Submissions

From: Justin Micallef [REDACTED]
Sent on: Wednesday, May 15, 2024 6:09:16 PM
To: dasubmissions@cityofsydney.nsw.gov.au
CC: [REDACTED]
Subject: Submission - D/2020/1224/A - 499-501 Kent Street SYDNEY NSW 2000 - Attention Bryan Li
Attachments: DA2020-1224A submission 15.05.2024.pdf (3.38 MB)

RE: Submission to DA/2020/1224/A and DA2023/868 – 499-501 Kent Street

Figure 3 - Image included in Objection letter dated 6 November 2023

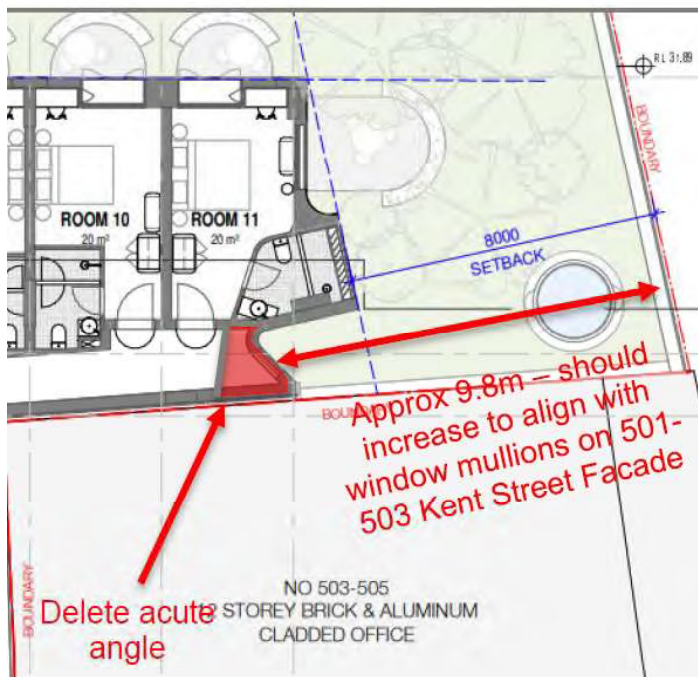
As outlined in our previous submission of 6 November 2023, compliance with the 10m upper-floor setback was sought to maximize the windows retained on the northern facade of 503-505 Kent Street, refer to Figure 3 below and Annexure 1. Figure 4 & 5 below, indicates how compliance with the 10m setback would retain one third of the northern windows to 503-505 Kent Street, aligning with the window mullion.

Figure 4 - Revised Plan in current Development Application indicating how a 10.3m setback at the northern boundary would align with the existing window mullion.

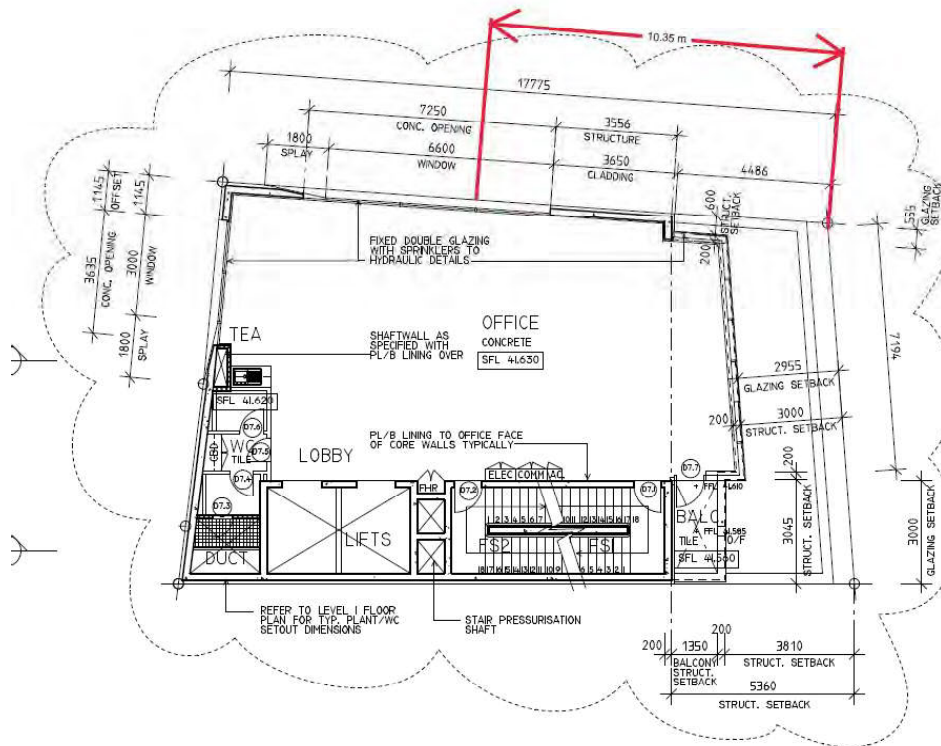
Figure 5 - typical Floor Plan of 503-505 Kent Street indicating how a 10.3m setback at the northern boundary would align with the existing window mullion and provide additional light into the floor plate if 499-501 Kent Street was Complaint with the DCP upper floor setback above a heritage Item.

It is unreasonable that compliance with the height control in the concept approval has resulted in a further request to decrease the Kent Street upper-floor setback, to increase the floor plate and attempt to maximize the gross floor area lost due to the height decrease, which was not adequately considered by the applicant in the design competition nor DA2023/868.

Figure 6 – Plan showing desired 10m upper floor setback and reinstatement of light well.

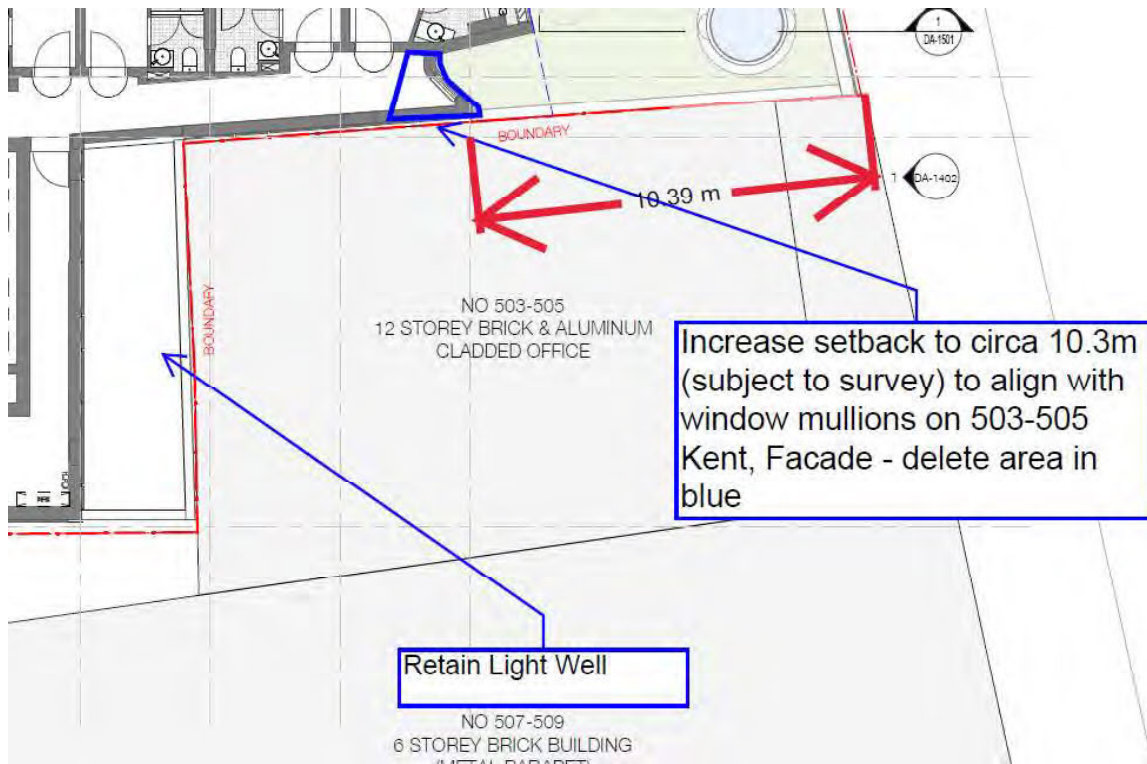
The removal of the lightwell to the west of 503-505 Kent Street further reduces the amenity of 503-505 Kent Street and removes an aspect of the design that was commended by the Design Excellence Jury.

We are seeking an amendment to the plans, such that DA2023/868 is revised to reinstate the light well and the upper-level setback is increased to be complaint with the DCP at 10m to retain the existing solar access afforded to 503-505 Kent Street within this 10m setback zone which could be achieved as per figure 6 below.

The amended DA2020/1224/A should be refused due to the significance of the proposed upper-floor setback non-compliance, or amended to reflect a compliant upper floor setback of 10m consistent with the DCP controls and the consequential amenity impacts on 503-505 Kent street as a result of the non-compliance.

Plans Showing New & Upgraded Structure

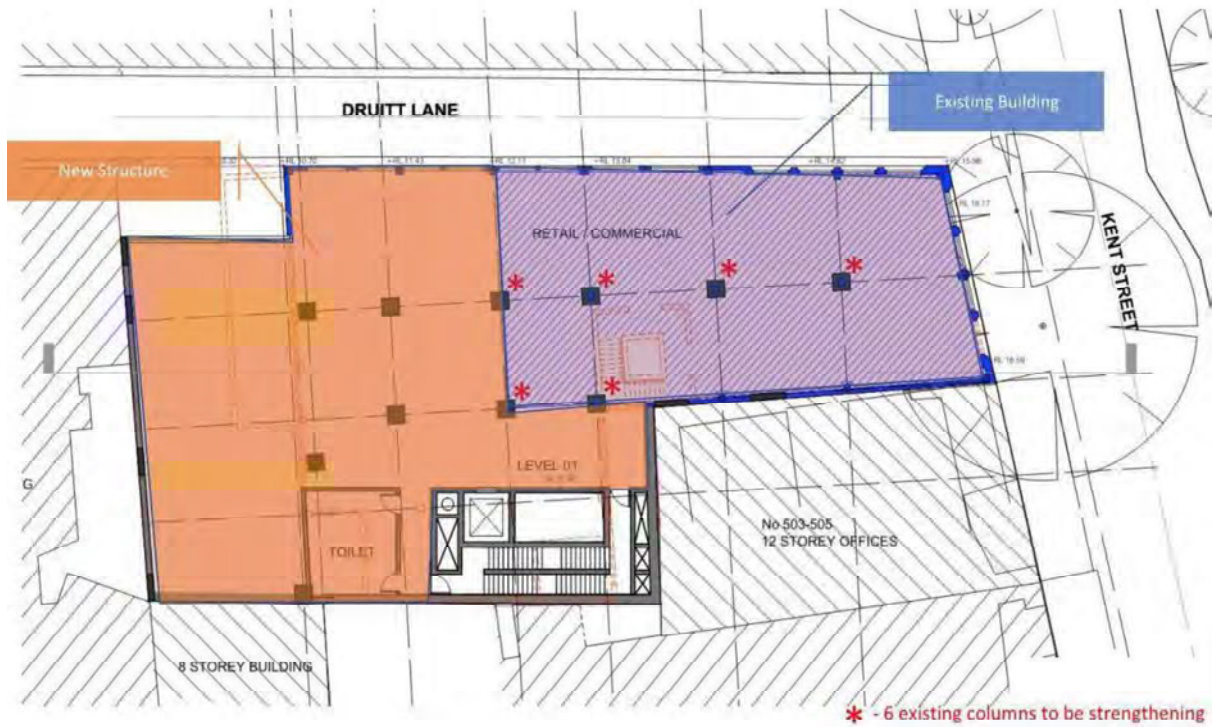
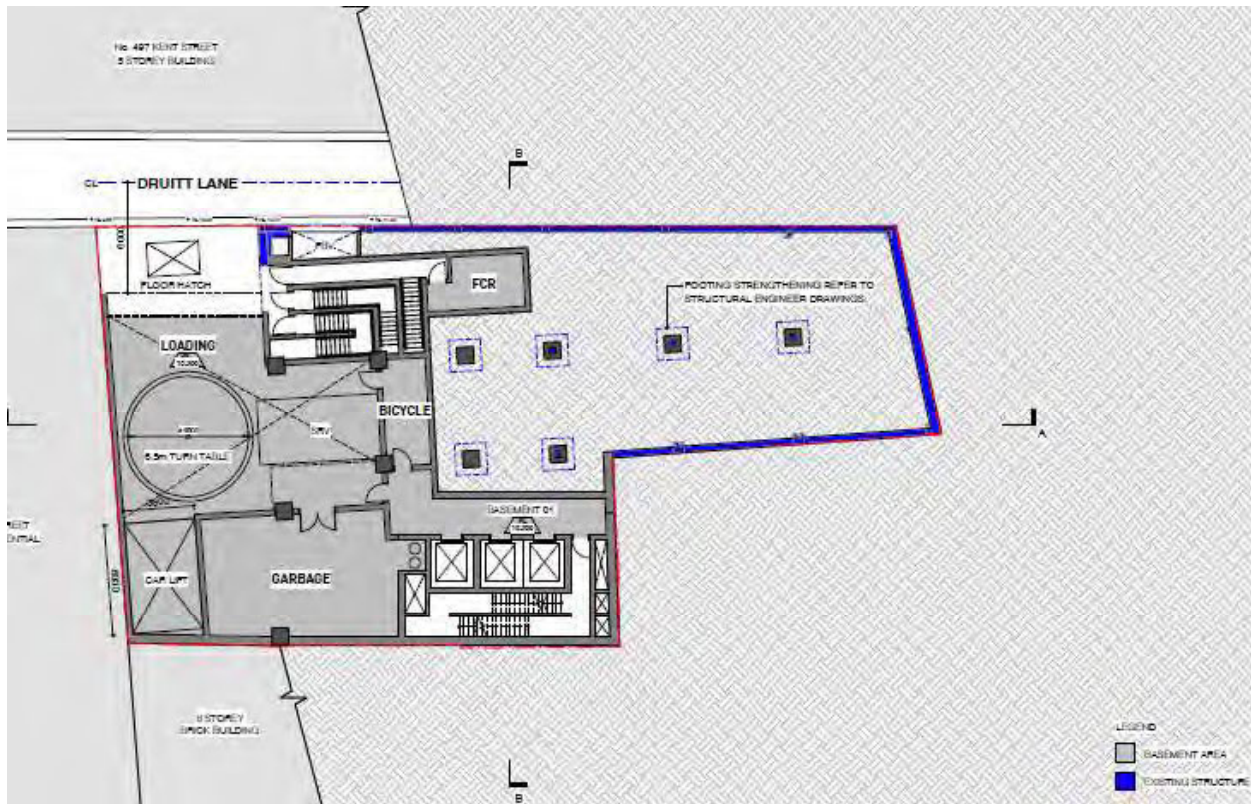
Original steel columns to be substantially enlarged (TTW).

Original basement footings to be strengthened (PTW).

Longitudinal Section of Proposed Development

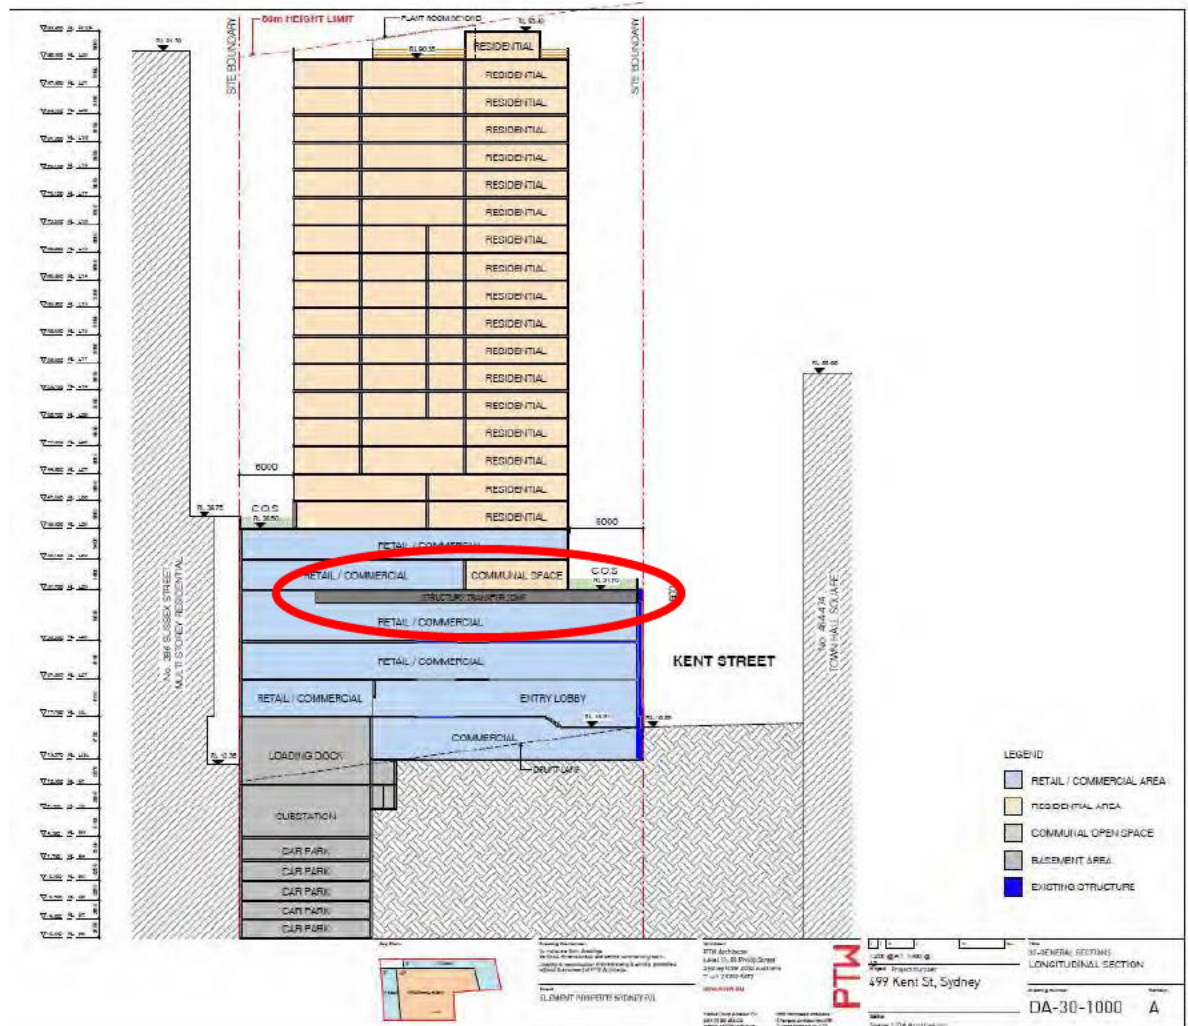
The Reference Design architectural drawing set (PTW, 11/7/19) also shows that a substantial structure transfer zone (refer Attachment B) will be required at the roof level of the existing building (the new Level 3). It is assumed this is necessary because the column grid setout of the proposed residential tower is different to the existing, although the TTW report does not mention this aspect of the structural concept.

Red oval shows Structure Transfer Zone (PTW).
